# UNITED STATES PATENT AND TRADEMARK OFFICE

APPLICATION NO.	FILING DATE	FIRST NAMED INVENTOR	ATTORNEY DOCKET NO.	CONFIRMATION NO.
10/737,349	12/15/2003	William F. Fling	Fling.04	5996

<b>Office Action Summary</b>	<b>Application No.</b> 10/737,349	<b>Applicant(s)</b> FLING ET AL	
	<b>Examiner</b> Katina M Wilson	<b>Art Unit</b> 2856

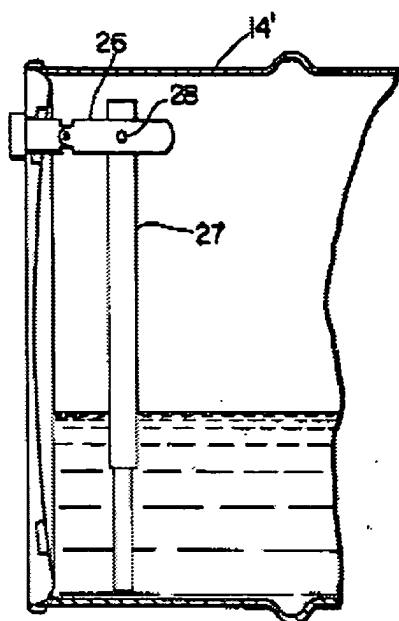
Fling et al teaches an adjustable frame liquid level measuring device comprising: housing 30; a flexible coupling having 1<sup>st</sup> section end 26 and 2<sup>nd</sup> section end 27 where the 1<sup>st</sup> end 26 is connected to the housing; a lower assembly connected to the 2<sup>nd</sup> end of the flexible coupling, the lower assembly including a float 19 constrained to a vertical

movement in response to changes in liquid depth/level in the container/drum 14 having at least one opening 13 and an actuator/transmission line 20 arranged to move in response to vertical movement of the float, the flexible coupling being arranged to maintain the actuator in a vertical orientation in the liquid when the actuator and the housing are out of vertical alignment; coupler mechanism/(rotatable shaft 36, universal joint 37, stub shaft 38, bevel gear 39, drive pulley 42, shaft 40, bevel gear 41) arranged to transfer movement of the actuator to the indicator 12 (col. 4-8, Fig. 1, 2, 7-9).

**FIG. 2**

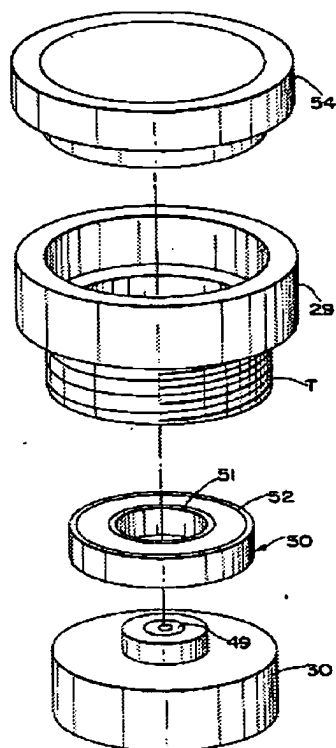
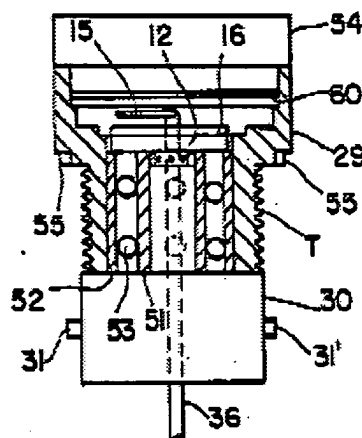
As to claim 15, Fling et al teaches the housing, the indicator, an insert mounted between the indicator and the housing are free to rotate about an axis centered on the housing (Fig. 10-11).

**FIG. 2**

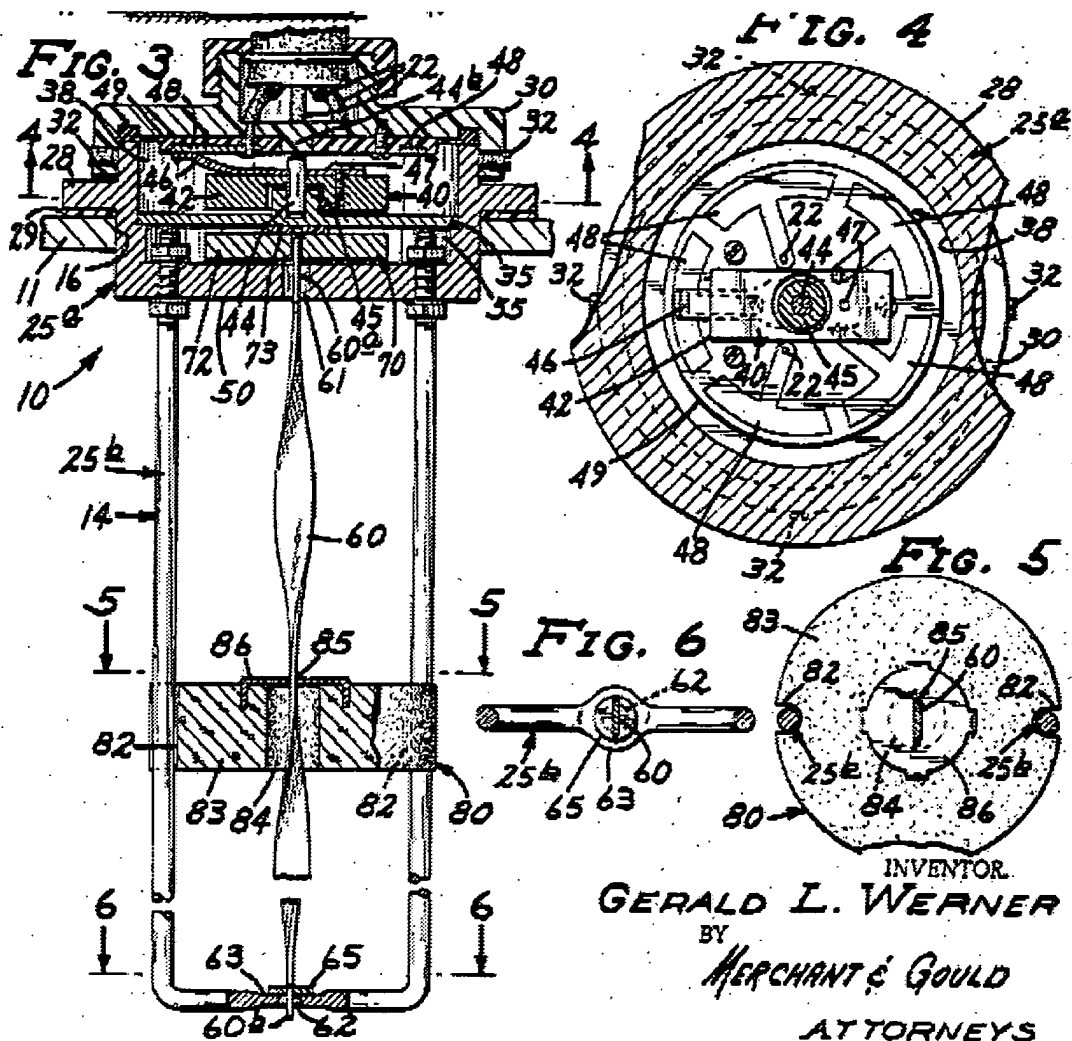
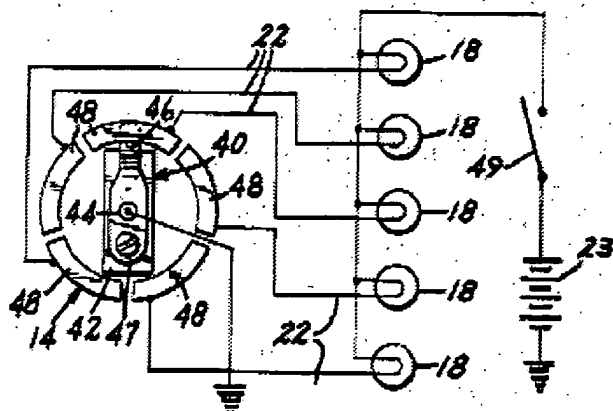
a pair of parallel rods the prior art clearly teach this limitation. Werner teaches a liquid level indicator, which include a pair of parallel rods 14 connected to a housing and arranged to be inserted into the liquid; the float 80 being slidably mounted to the rods such that the float is constrained to linear movement lengthwise along the rods.

As to claim 3, Werner teaches the float 80 includes a cork 83 having two oppositely disposed recesses 82 in the outer edges thereof engaging frame 25b so as to prevent rotational movement of the float, rod appears to be constrain the float to linear movement along the rods.

As to claim 12, Fling does not teaches the coupling mechanism includes a magnetic coupler arranged to couple rotational movement of the actuator to the indicator. Werner teaches the coupler mechanism/shaft 44 includes a magnetic coupler arranged/magnet assembly 40 to couple rotational movement of the actuator/helical element 60 to the indicator (col. 2-4; fig. 2, 3, 5).
